Access Compliance Report

Public Rights-of-Way

Intersection ID: 24585	Main Street: REA_CROFT_DR	Cross Street: REA_RD	Location:	SE
ADA ID: 57526C9B3DFF	Ramp Type: Perp	Initial Pass/Fail: Fail	Overall Compliance: No	Severity Score: 10
Codes/Mitigation Info/Possible Solution		Field Measurements/Component Compliance

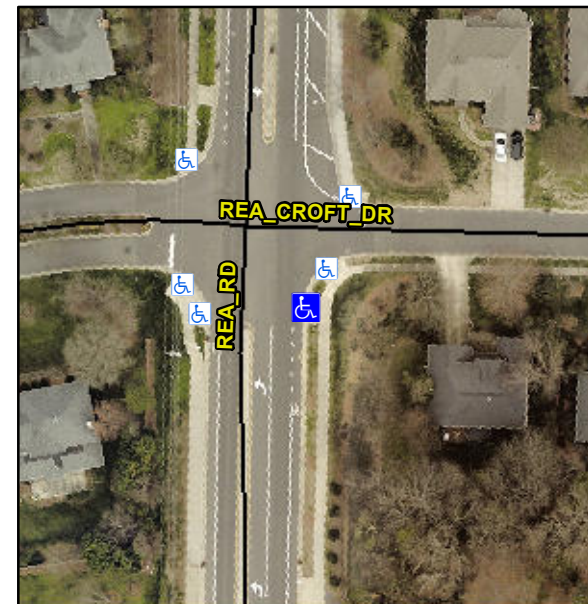
R304.5.1, R304.5.3

Compliance	Description	Data	Compliance	Description	Data
N/A	Ramp Length (in)	73.0	Yes	Ramp Slope (%)	5.6
No	Ramp Width (in)	47.0	No	Ramp XSlope (%)	2.2
N/A	Flare Type LT	N/A	N/A	Flare Type RT	N/A
N/A	Flare Slope LT (%)	N/A	N/A	Flare Slope RT (%)	N/A
N/A	Flare Traversable LT?	N/A	N/A	Flare Traversable RT?	N/A
N/A	Landing Length (in)	N/A	N/A	DWS Provided?	N/A
N/A	Landing Width (in)	N/A	N/A	DWS Contrast?	N/A
N/A	Landing Slope (%)	N/A	N/A	DWS Length (in)	N/A
N/A	Landing X Slope (%)	N/A	N/A	DWS Full Width?	N/A
N/A	Landing Curb? (Y/N)	N/A	N/A	DWS Offset (in)	N/A
N/A	Shared Landing?	N/A			
N/A	Gutter Ponding?	N/A	N/A	Gutter Slope (%)	N/A
N/A	Gutter Lip Ht (in)	N/A	N/A	Gutter X Slope (%)	N/A
N/A	Painted X Walk1?	No	N/A	Painted X Walk2?	N/A
	X Walk 1 Direction	To W		X Walk 2 Direction	N/A
N/A	X Walk 1 Width (in)	N/A	N/A	X Walk 2 Width (in)	N/A
	X Walk 1 Slope (%)	1.5		X Walk 2 Slope (%)	N/A
	X Walk 1 X Slope (%)	0.7		X Walk 2 X Slope (%)	N/A

Remove & Replace Entire Ramp.
